Subject: AP1000 COL Standard Technical Report Submittal of APP-GW-GLN-106, (TR 106),  
Revision 0

1. APP-GW-GLN-106, Revision 0, "AP1000 Licensing Design Changes for Mechanical System and Component Design Updates," Technical Report Number 106

**WESTINGHOUSE ELECTRIC COMPANY**  
**AP1000 Licensing Design Change Document**

**Title:** AP1000 Licensing Design Change Document for Generic Reactor Coolant Pump

Figure 1 CRDM Cooling Air Flow Path in IHP

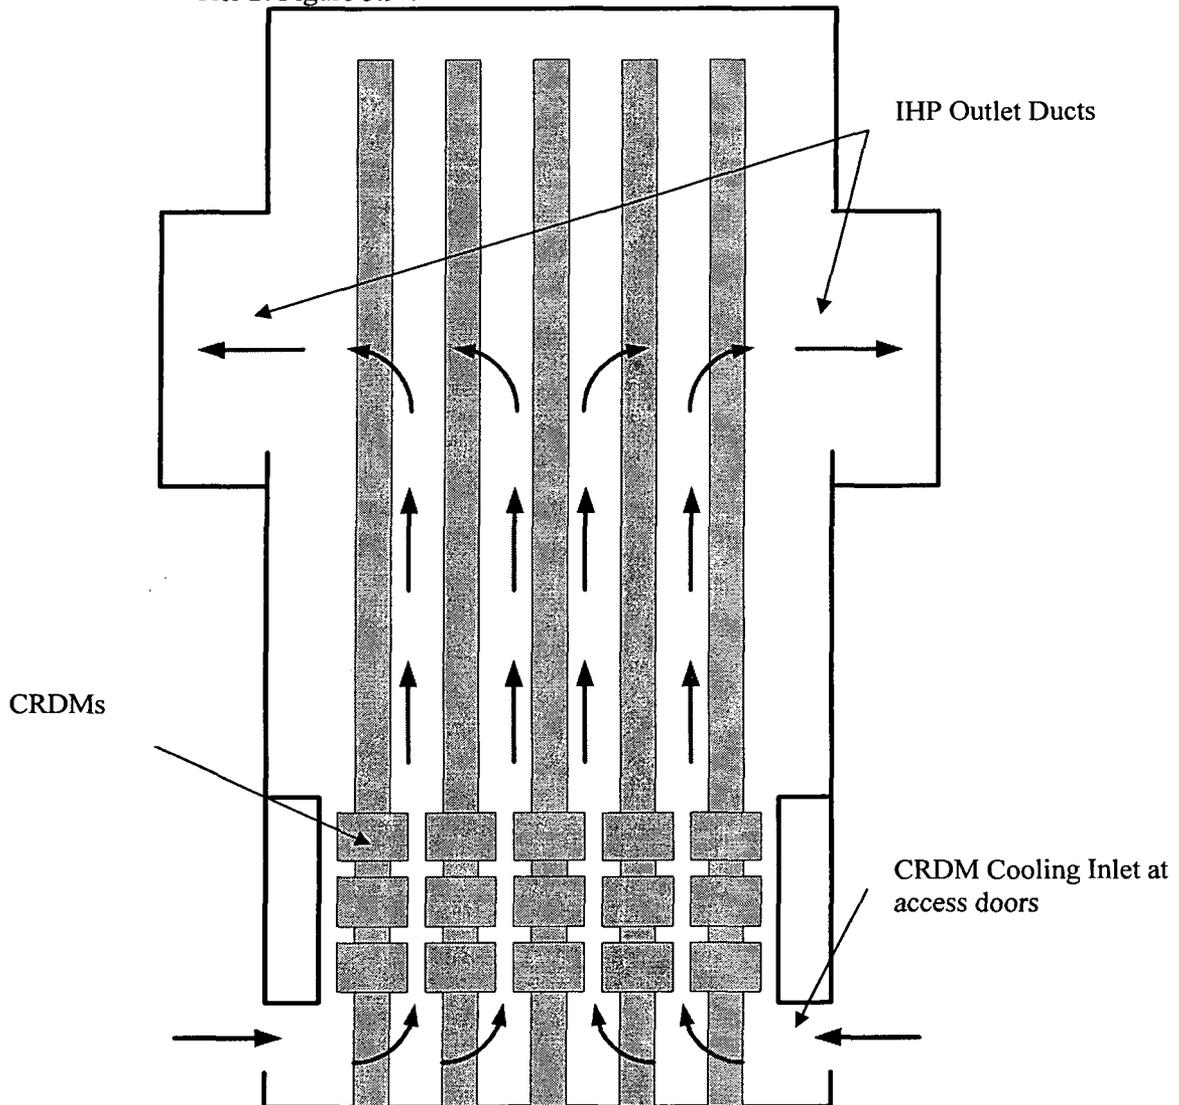
**2.d Design Change 185, IHP Design:**

One of the functions of the Integrated Head Package is to provide cooling to the CRDMs. A design change has been made to the CRDM cooling system to reduce the system pressure drop and CRDM air flow exit temperature. This has been achieved by removing the internal baffles that caused a high pressure drop. The CRDM airflow now is sucked in through the CRDM inspection doors, past the CRDMs and exits near the top of the IHP shroud. The airflow path is shown in the Figure 1 below. Figure 1 below supersedes the figure originally provided as part of the response to RAI TR61-01. TR 61 is Westinghouse document APP-GW-GLN-014, Revision 0 "AP1000 Integrated Head Package."

The IHP design change has resulted in updates to the following subsections of the DCD:

- Tier 2: Figure 3.9-7

Revise Figure 3.9-7 as follows:

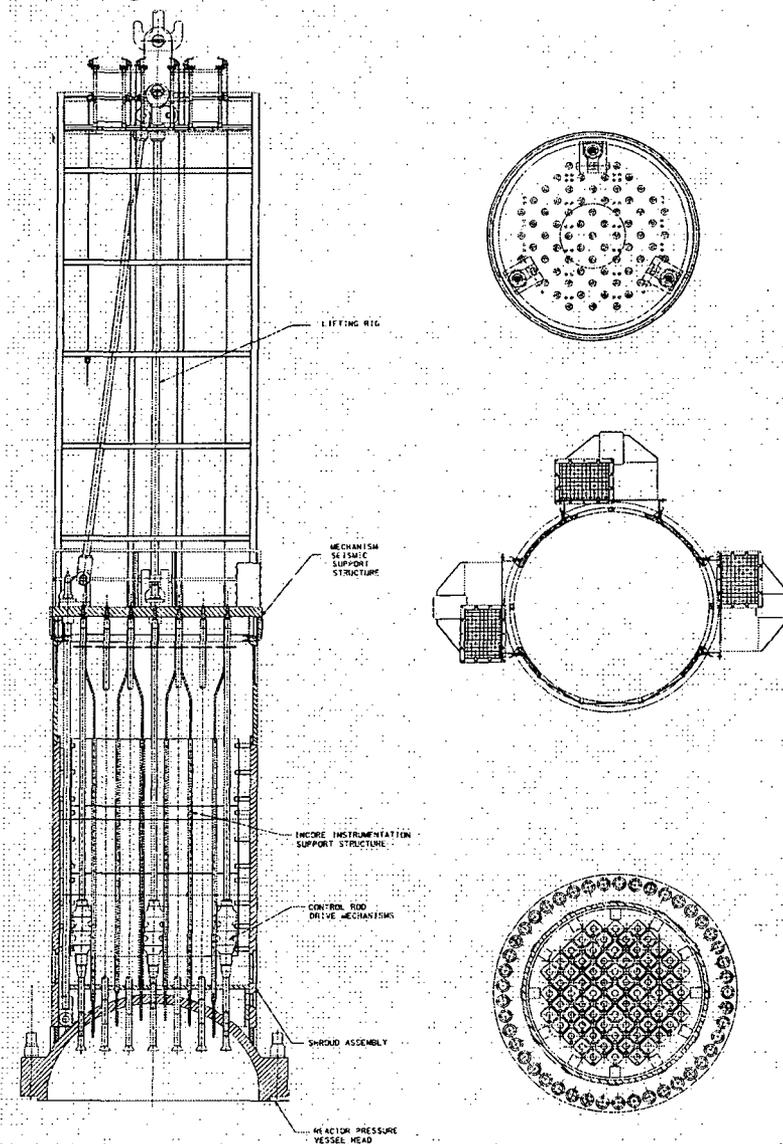
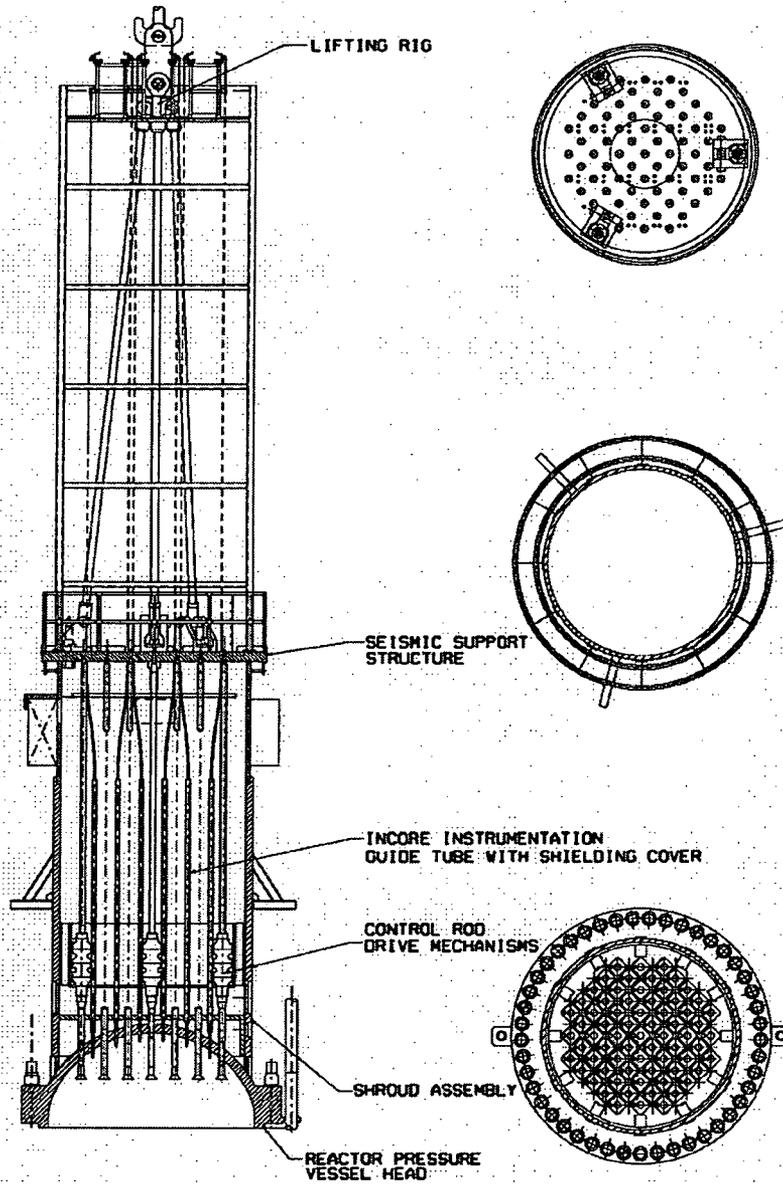
Current Figure 3.9-7 (Rev. 15 AP1000 DCD):

Updated Figure 3.9-7:
